STAFF REPORT
COMMUNITY DEVELOPMENT DEPARTMENT

SUBJECT: H-2020-0092
Goddard Creek Community

LOCATION: Northwest corner of W. McMillan Rd.
and N. Goddard Creek Way.

C. Landscape Plan (date: 9/2/2020)

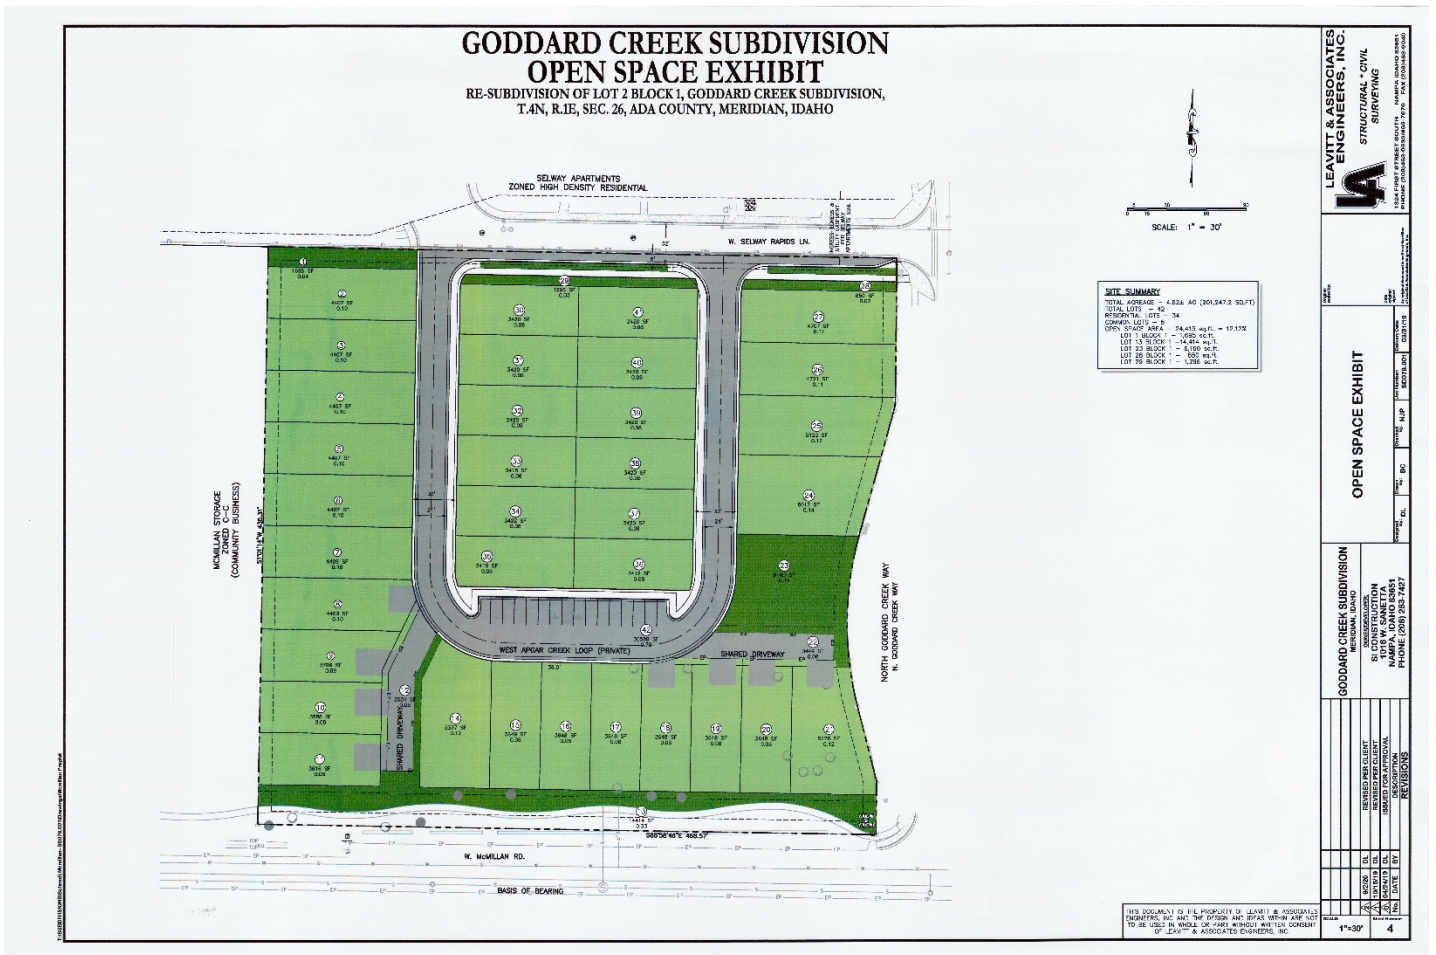
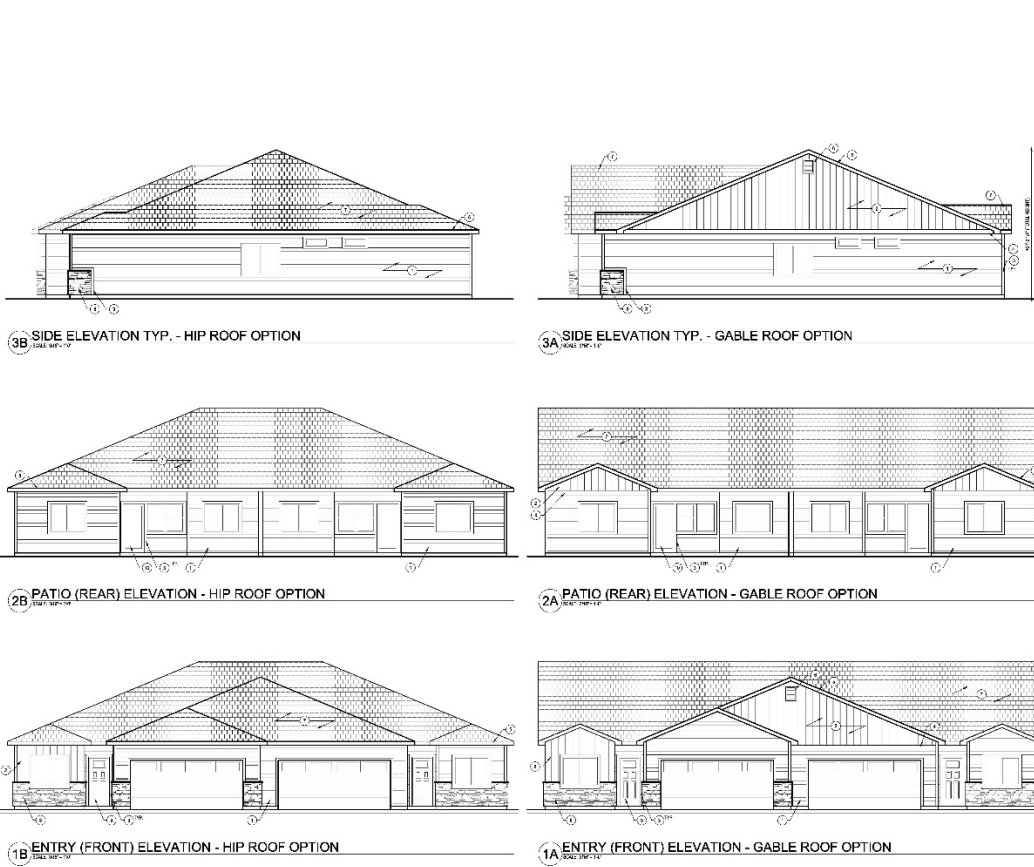
The Applicant has proposed a larger common open space lot shown to include five (5) Class II trees which exceeds the requirement of one (1) tree per 8,000 square feet of open space. All other landscape areas appear to be landscaped per city code requirements including those areas with proposed seepage beds.

3. The landscape plan included in Section VII.C, dated 10/18/19 shall be revised as follows:
 - a. Provide the details of the site amenities with the submittal of the final plat application.

F. Public Works – Water Markup

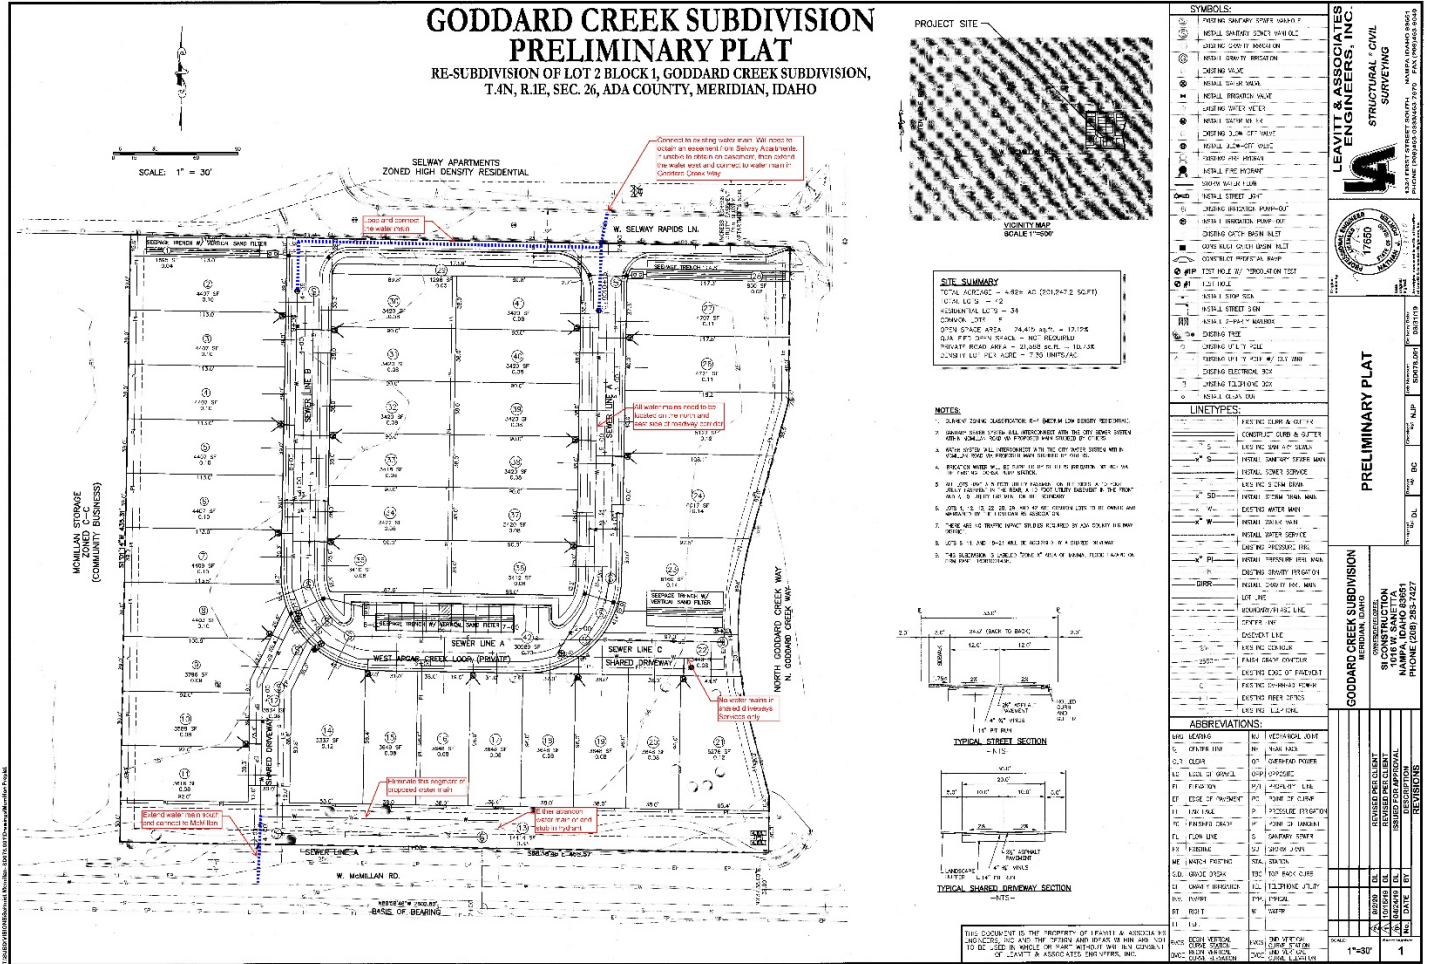
One issue presented by Public Works is regarding the proposed sewer and water mains shown in the common drive in the southeast corner; Public works requires that if the common drive serves three (3) or less properties that only service lines should be constructed and not mains.

The main issue is regarding the water line layout and a requirement to connect to the existing main within W. Apgar Creek Lane from both of the proposed stubs off of this road to create a looped system. The Applicant would need to obtain an easement from Selway Apartments to connect their existing main. In addition, Public Works is requesting that the Applicant change the connection point to the water main within McMillan Road to connect directly south of the emergency access instead of heading east within the landscape buffer.

1. Remove the water mainline from the shared driveway at the southeast, water services will need to be extended from the mainline.
2. Instead of connecting the water main to the southern stub, extend the water main south directly to McMillan to eliminate unnecessary parallel water main. The existing stub will either need to be abandoned or end in a hydrant.

3. Loop the two deadend water mains near the north boundary line and connect to existing water main in Selway Rapids Ln to create a secondary connection and eliminate two deadend mains. An easement will need to be obtained from Selway Apartments in order to connect to the water main in Selway Rapids
